DEVELOPMENT REVIEW BOARD  
**SUPPLEMENTAL SUBMITTAL**

PROJECT NO. PR-2018-001579

SUBMITTAL DESCRIPTION: Based on the comments from the DRB Hearing January 5, 2022 we requested a deferral

**RE: PR-2018-001579 – WINROCK TOWN CENTER, SI-2021-00304 SITE PLAN, SI-2021-00305 SITE PLAN AMENDMENT, SUMMARY PLAT (PLAT OF EASEMENTS ONLY)**

Design Review Committee	City Engineer	Ms./Day/Yr.	Ms./Day/Yr.
City Project No.	Zone Map No.	Sheet	Of
-	J-19-Z		EXHIBIT 9

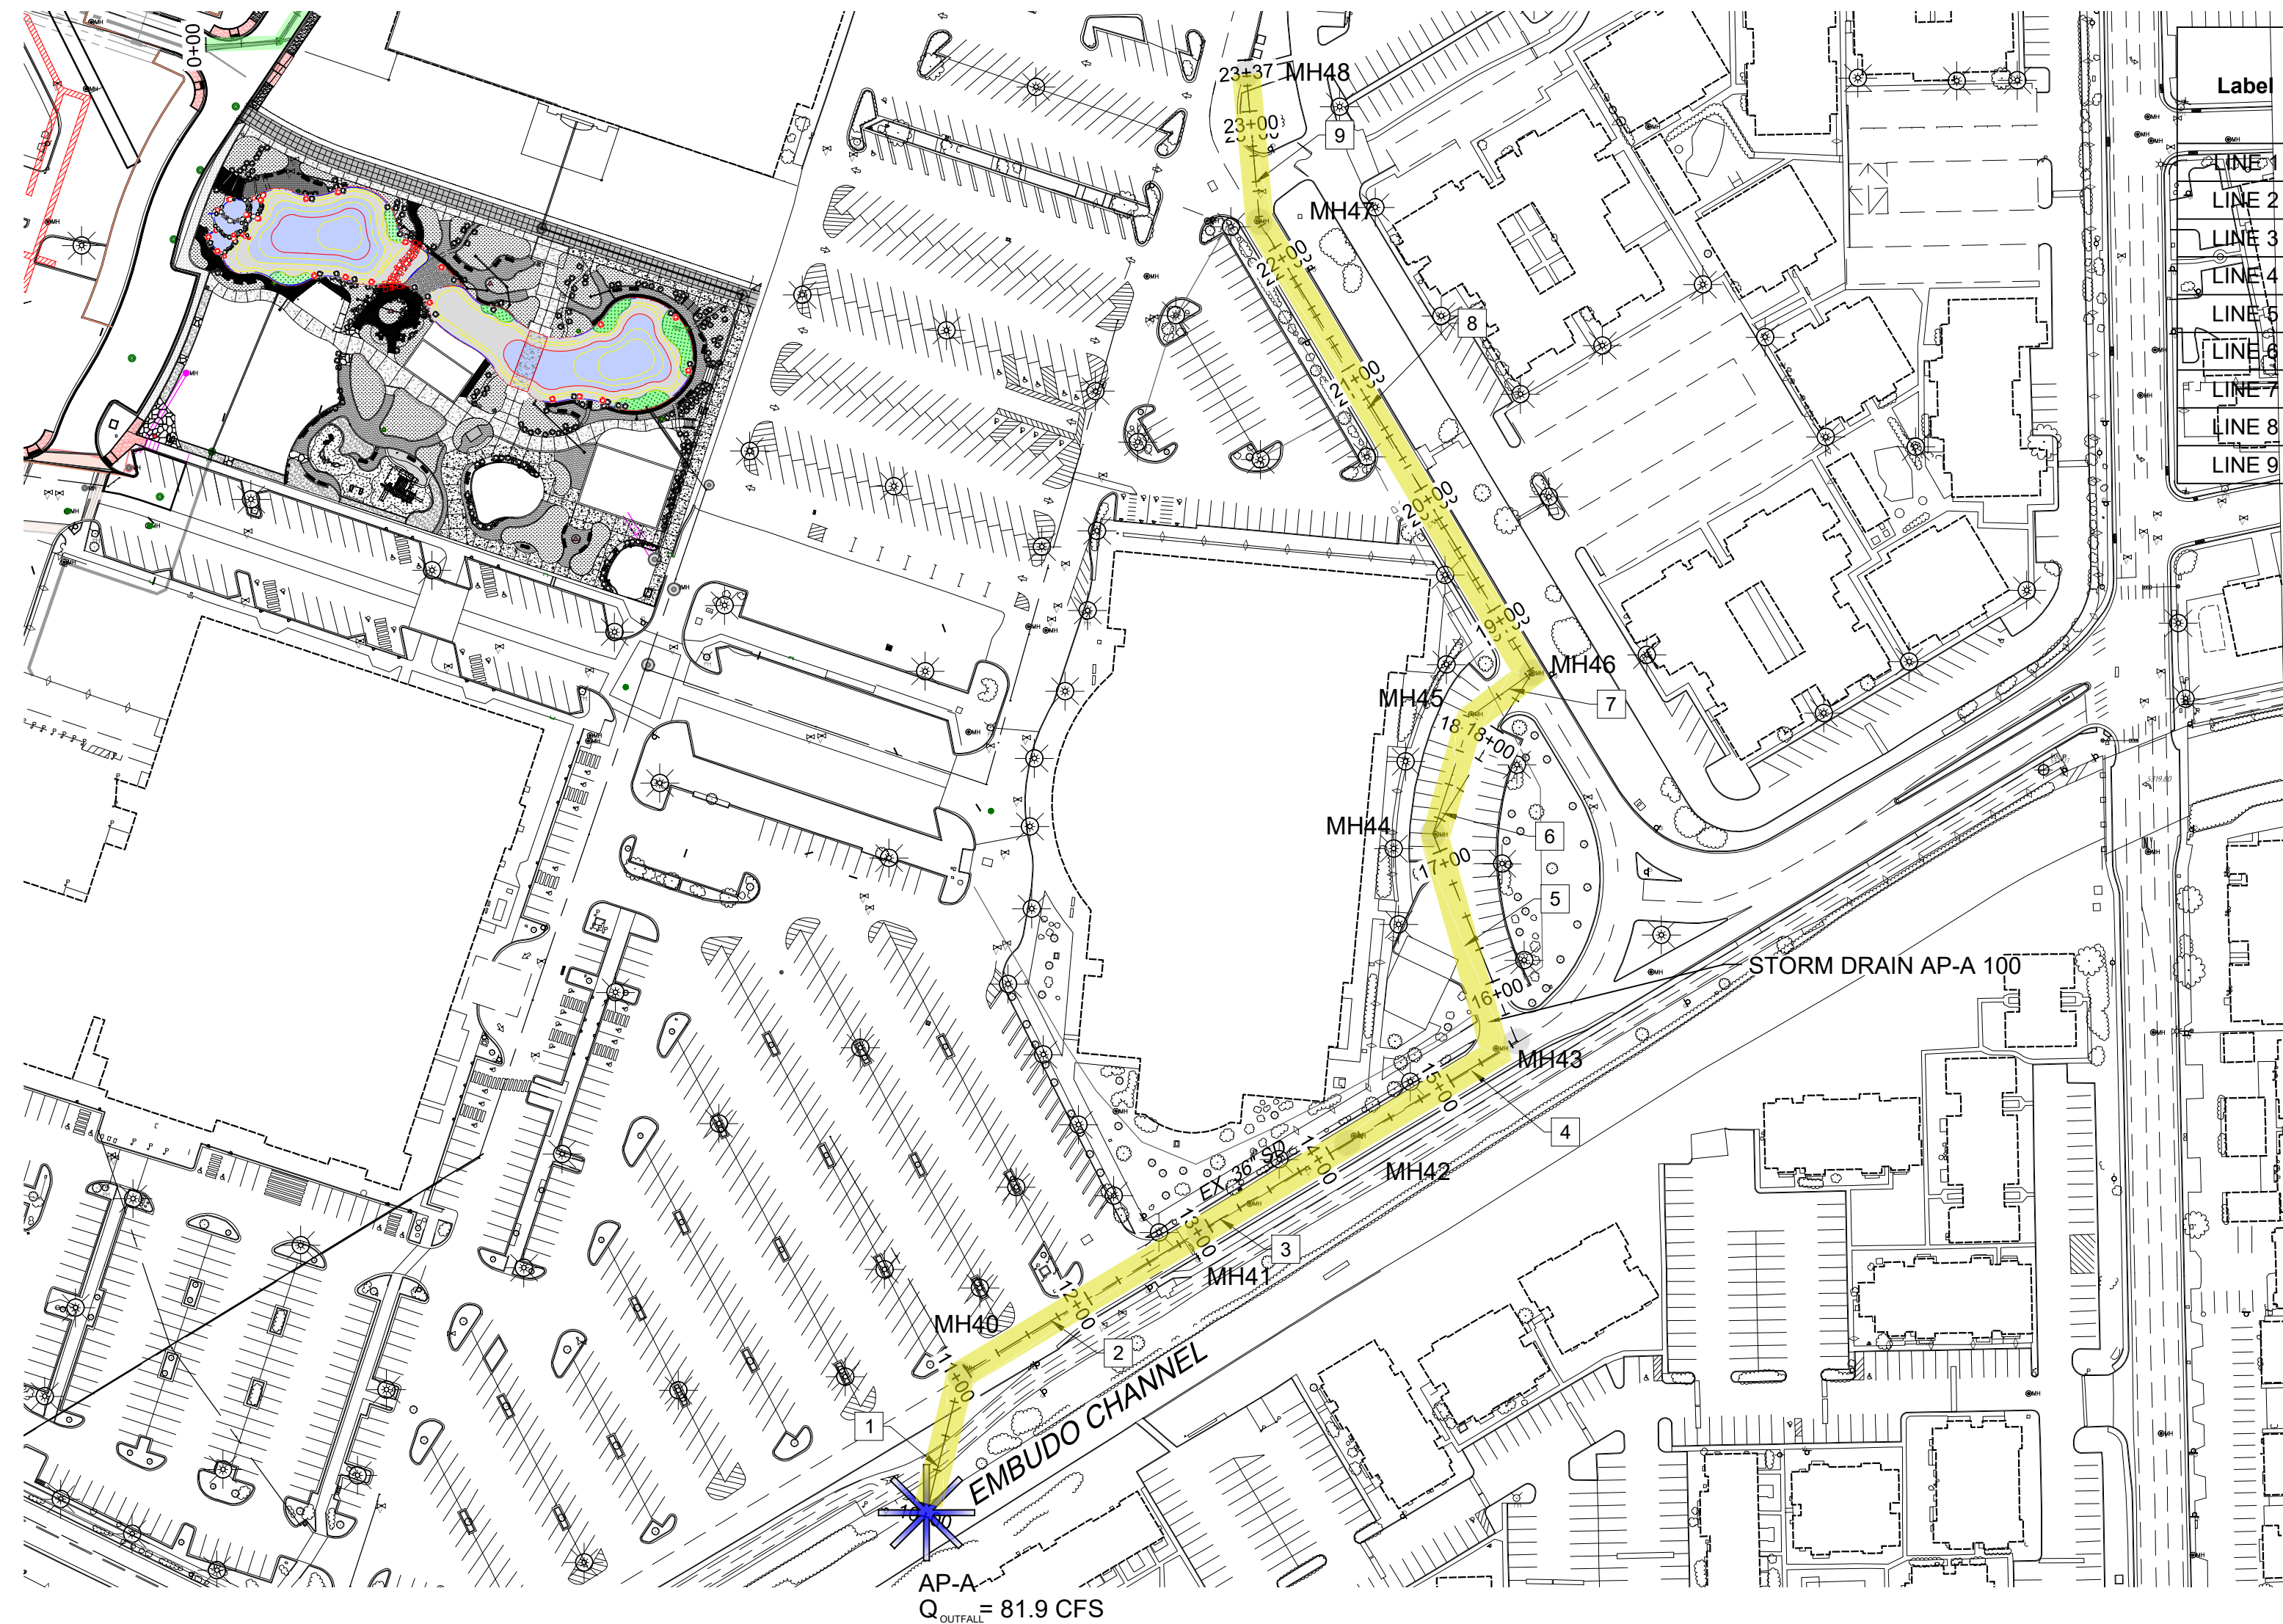
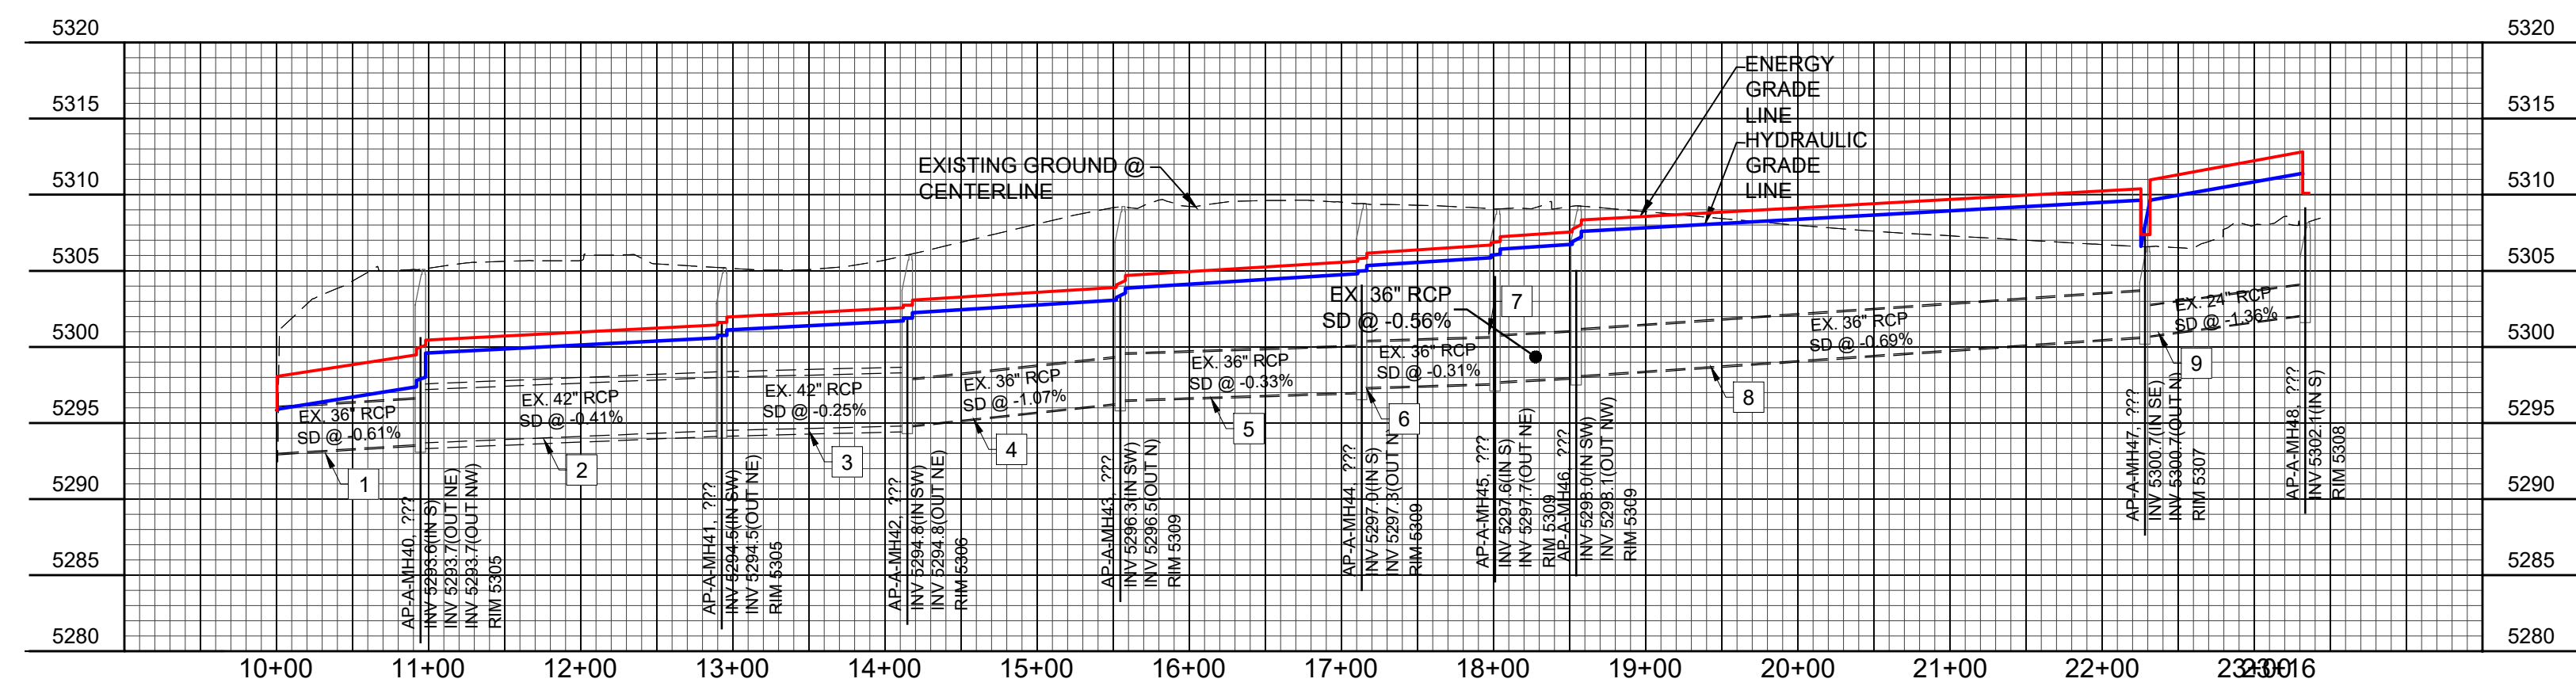
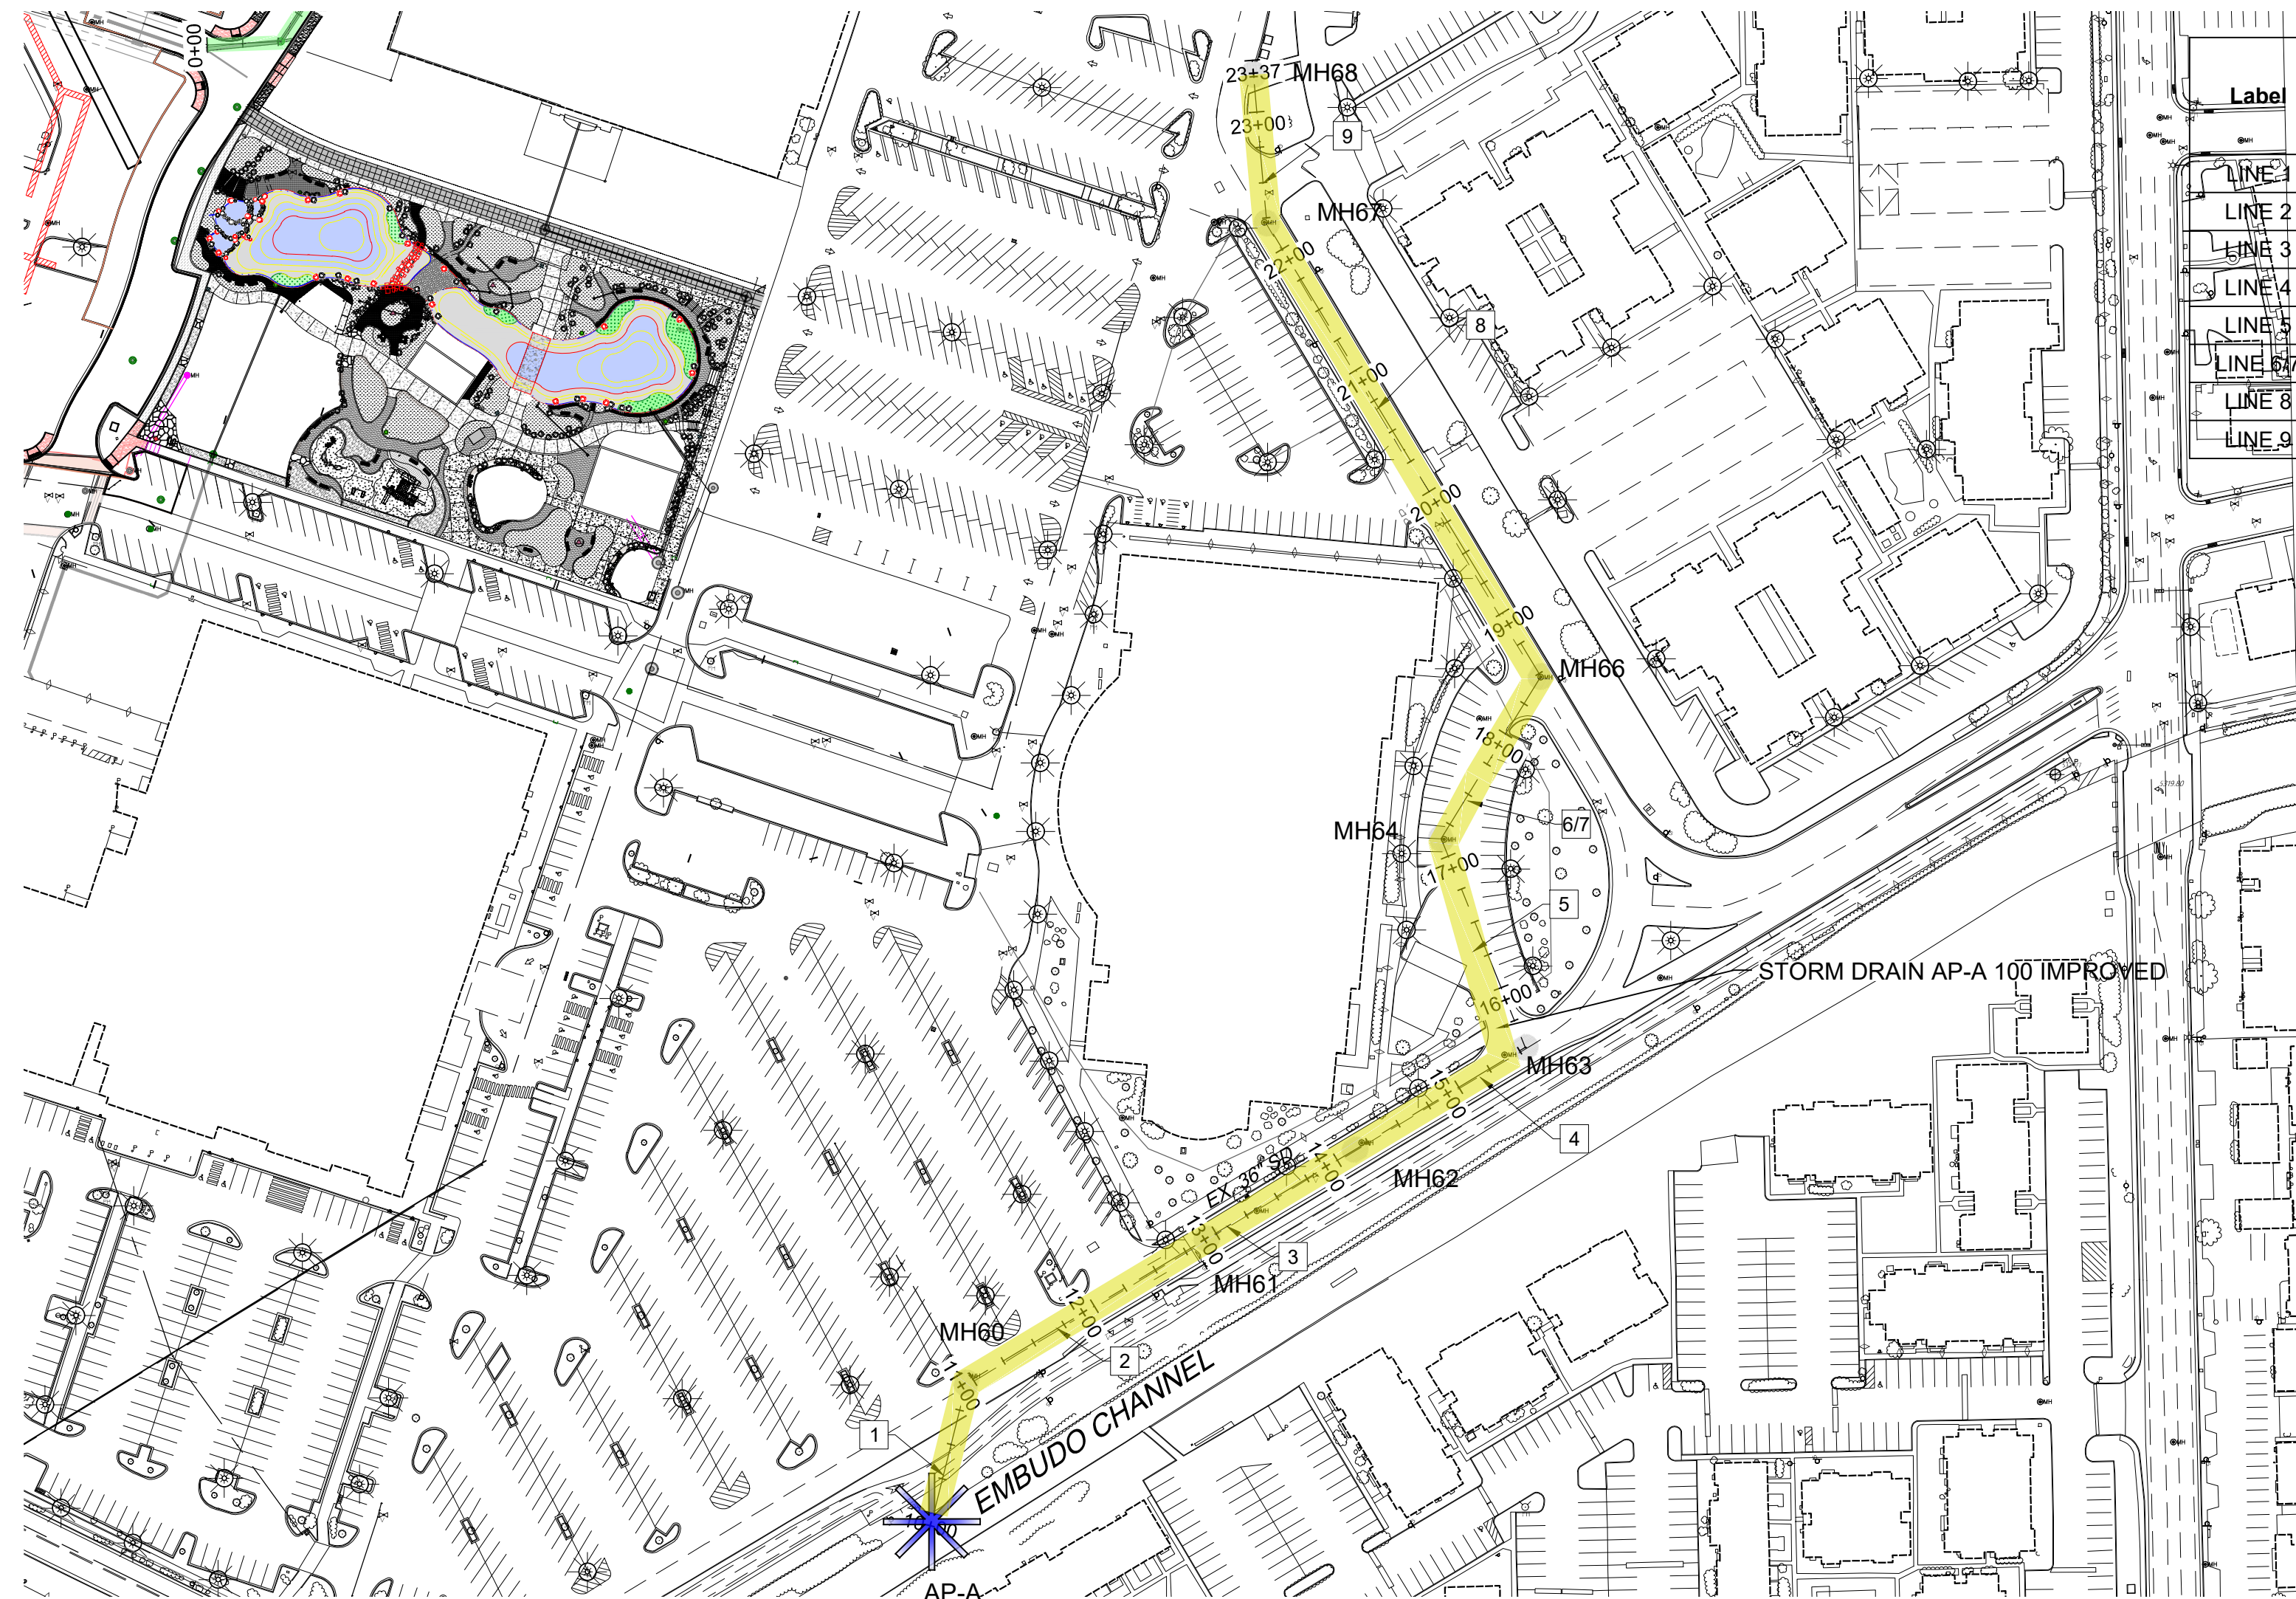
As presented within the DIP the existing storm drain network AP-A may have been incorrectly modeled for the revised flowrates in previous analyses. The existing storm drain pipes were originally designed to convey 46 CFS. With the revised development in that area, the peak flowrate of AP-A increased to 82 CFS which causes the existing pipes to have insufficient capacity during the 100-year storm event. Refer to Exhibit 8 for the existing condition of network AP-A. As a future solution to correct this pipe network, the storm drain should be upsized and/or replaced with an alternate material to safely convey the 100-year peak flowrate. Refer to Exhibit 9 for the proposed improvements to network AP-A.
